ADDENDUM NO. 1
Amelia River Waterfront Stabilization Parking Lots C & D
City of Fernandina Beach
Invitation to Bid # 21-06
Issued: May 25, 2021

III. Changes to Drawings: (See attached)

Drawing name: F:\PASSERO\FHB\99000047.0095 FHB Waterfront\Airport\C5-01-PROF_XSCT.dwg C6-5_XSCT May 25, 2021 5:56am by: EBredestege

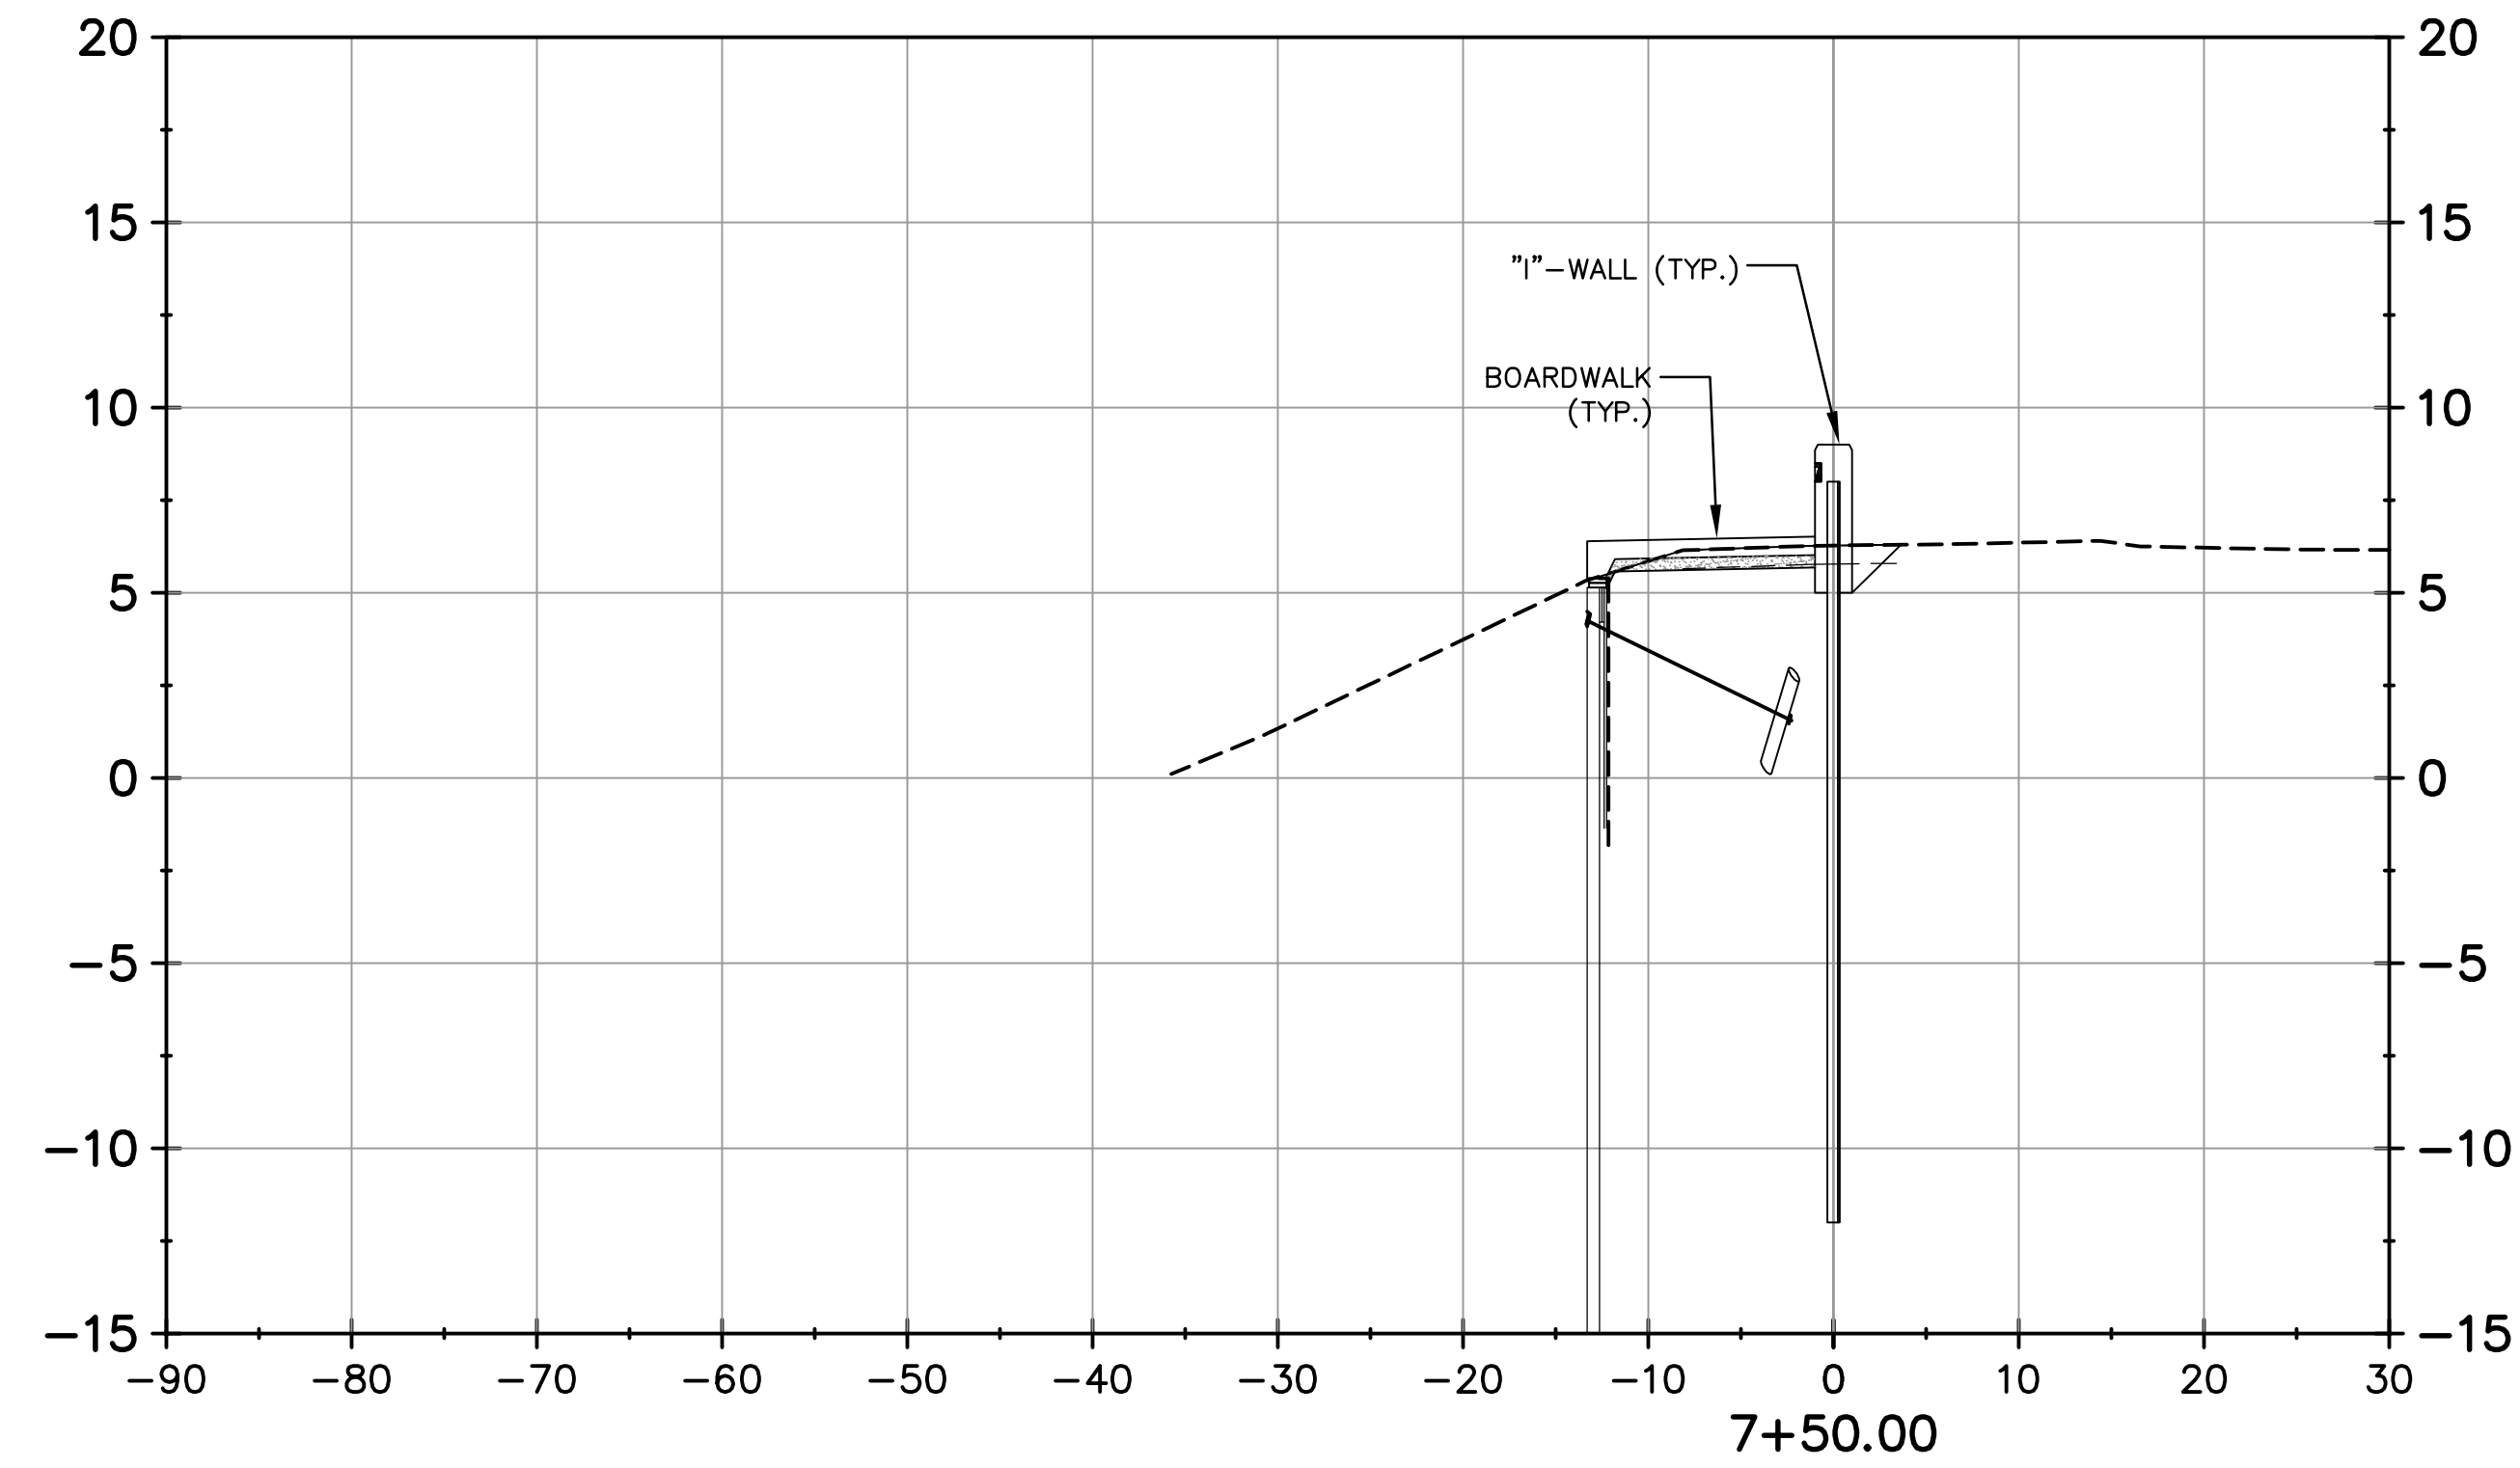
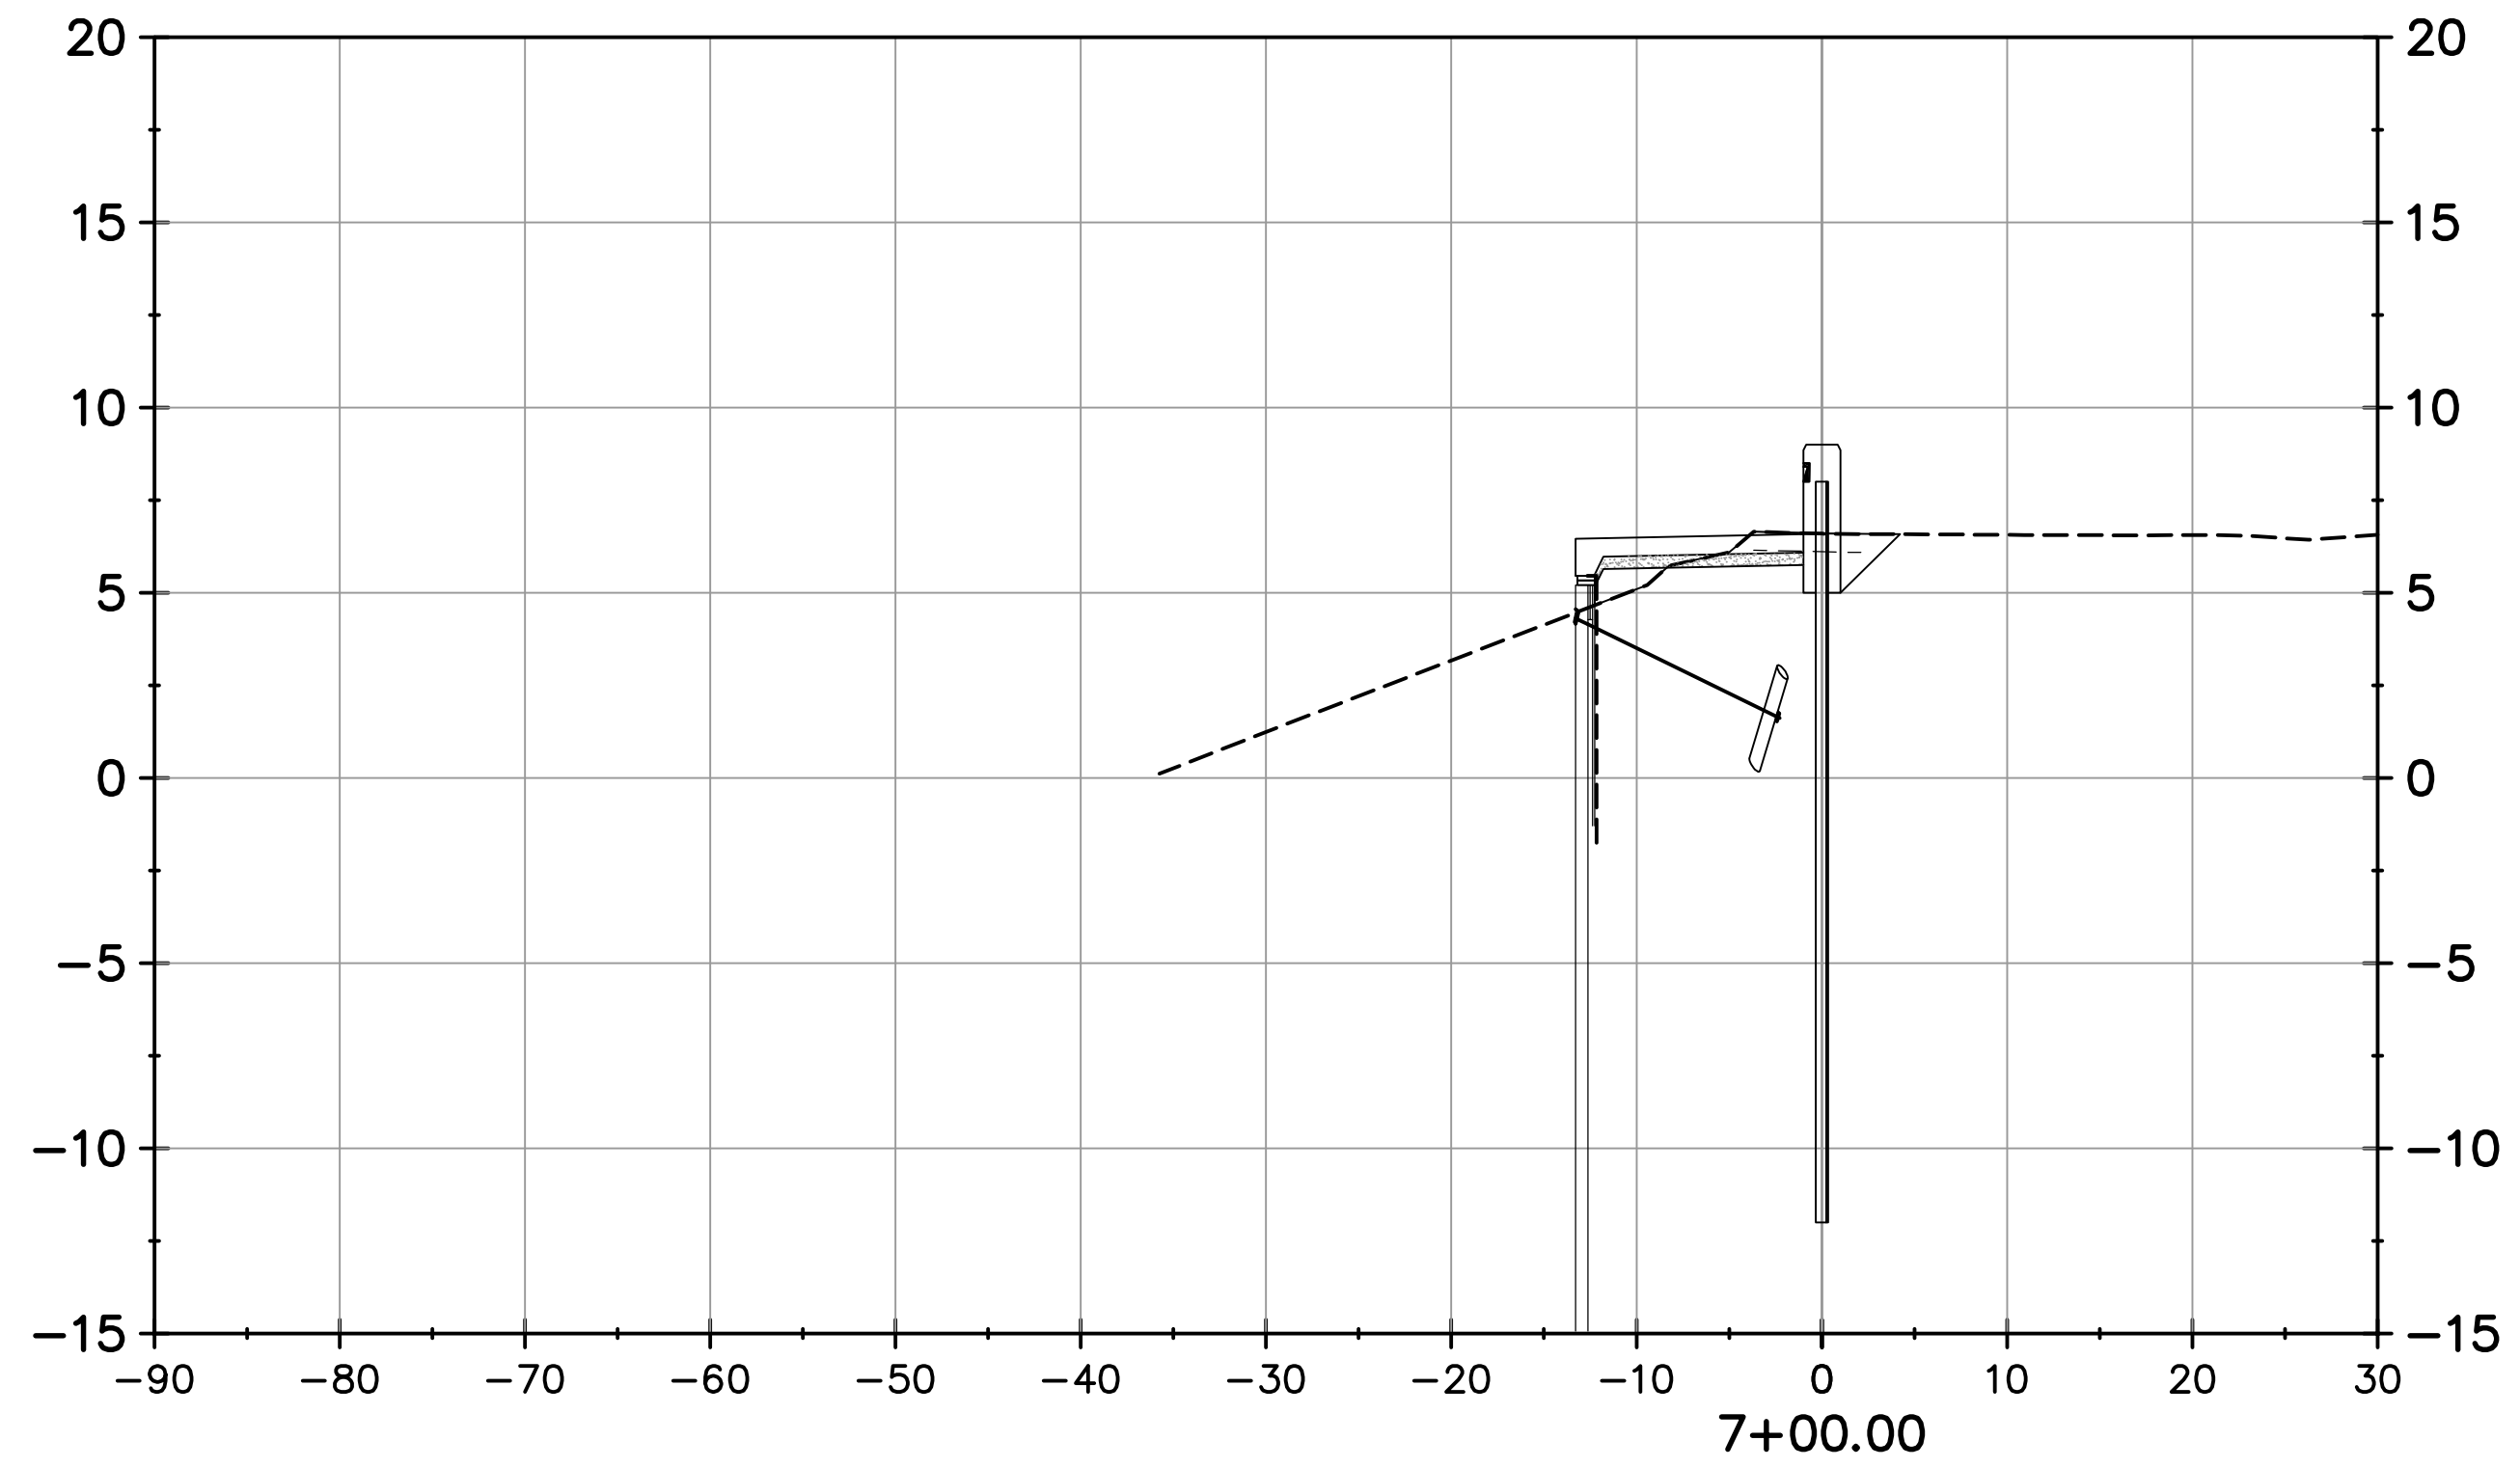
- 24) Sheet C6-5 - Revised I-Wall & Boardwalk Alignment and Cross Sections Adjusted.
- 25) Sheet C6-6 - Revised I-Wall & Boardwalk Alignment and Cross Sections Adjusted.

ALIGNMENT MOVED; CROSS SECTIONS ADJUSTED
